Technical Bulletin

PDI-508W-LCD-13 Support Arm Product Label Replacement

PDI-508W-LCD-13 Arm Label Replacement

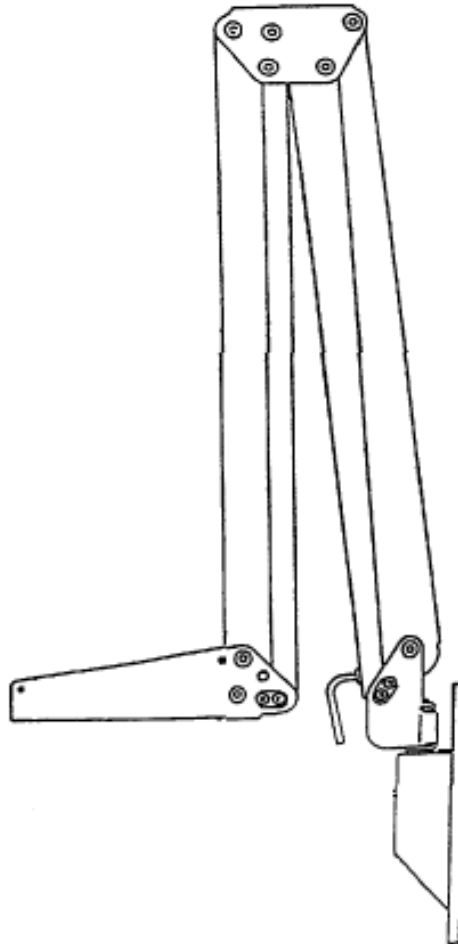
All PDI products come with a product label identifying the product. Unfortunately, during a production run of support arms, an incorrect and outdated label format was used on the LCD version of the 508 series support arm.

The product label is located on the base of the arm directly above the pivot pin. Note, if the arm is installed in a wall mount the pivot pin will not be visible. The incorrect label will bear the model number PDI-508W-LCD-13, show a date of manufacture before May 16, 2003 and also be missing the UR Underwriter Laboratories recognition mark.

Remove the suspect label and replace with the revised label. Contact PDI for a replacement label. NOTE: Each replacement label is serialized and requires a "one-for-one" match with the original serial number as it appears on the label when replaced.
